UNITED STATES
NUCLEAR REGULATORY COMMISSION
WASHINGTON, D. C. 20555

FACILITY: Browns Ferry Nuclear Plant, Units 1, 2, and 3

SUBJECT: SUMMARY OF THE DECEMBER 16, 1992 MEETING REGARDING DESIGN AND
OPERATION OF THE BROWNS FERRY HARDENED WETWELL VENT

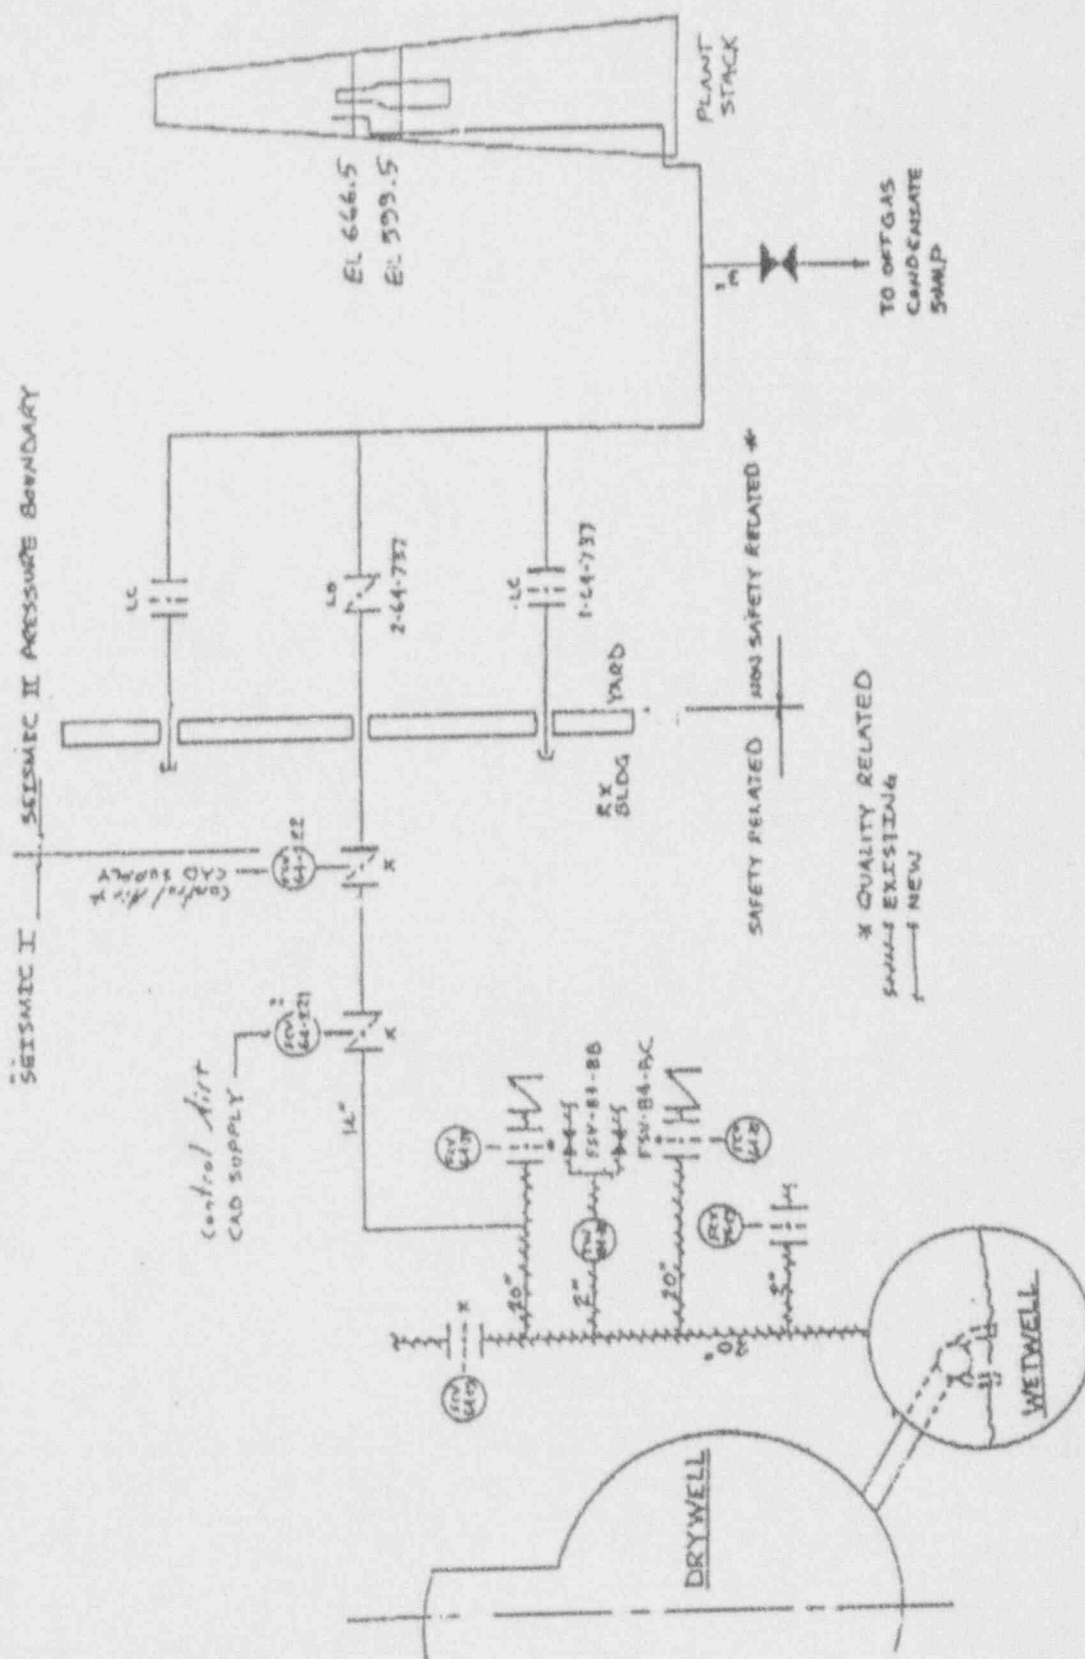
This meeting was held to follow up on a finding from a team inspection conducted at BFN which examined engineering design change packages. This finding noted that the hardened wetwell vent design included three drain valves which required local manual action when the vent is operated. The inspection team was concerned that these local actions may be prevented by high radiation fields in the event of core damage, and, therefore, plant operators would be unable to perform actions called for in the Browns Ferry emergency operating procedures.

In response to the concern raised by the team inspection, TVA stated that they will install float valves on two of the three drain lines. These float valves will operate passively, eliminating the need for local operator action on these lines. The third drain valve is located within the plant stack. TVA is evaluating whether or not this valve can be opened during an accident and left

open without increasing ground-level radiation source terms and associated doses beyond regulatory limits for design basis events. If this valve can be left open, the team's concern regarding local operator action will be resolved. TVA will inform the staff of the results of its evaluation.

TOPIC	SPOKESMAN
ISSUES	J. E. McCARTHY
<ul style="list-style-type: none">• CURRENT DESIGN REQUIRES MANUAL OPENING OF A DRAIN VALVE IN THE STACK PRIOR TO INITIATION OF VENTING• CURRENT DESIGN REQUIRES MANUAL CYCLING OF LOW POINT DRAIN VALVES PRIOR TO RE-USING THE VENT• EMERGENCY OPERATING INSTRUCTIONS ARE SYMPTOMATIC AND REQUIRE VENTING AT ELEVATED CONTAINMENT PRESSURES TO PRECLUDE CONTAINMENT FAILURE REGARDLESS OF RADIOLOGICAL CONDITIONS

TOPIC	SPOKESMAN
CURRENT ACTIVITIES	J. E. MCCARTHY
<ul style="list-style-type: none">• CALCULATIONS BEING PERFORMED TO DETERMINE IF STACK DRAIN VALVE CAN BE LEFT OPEN FOR DESIGN BASIS ACCIDENTS (GROUND LEVEL RELEASE)• STACK DRAIN VALVE ISSUE MUST BE RESOLVED CONCURRENT WITH NRC REVIEW OF CONTROL ROOM EMERGENCY VENTILATION SYSTEM'S CONFORMANCE TO GDC 19• LOW POINT DRAINS VALVES TO BE REPLACED WITH FLOAT VALVES TO PRECLUDE MANUAL OPERATOR ACTION
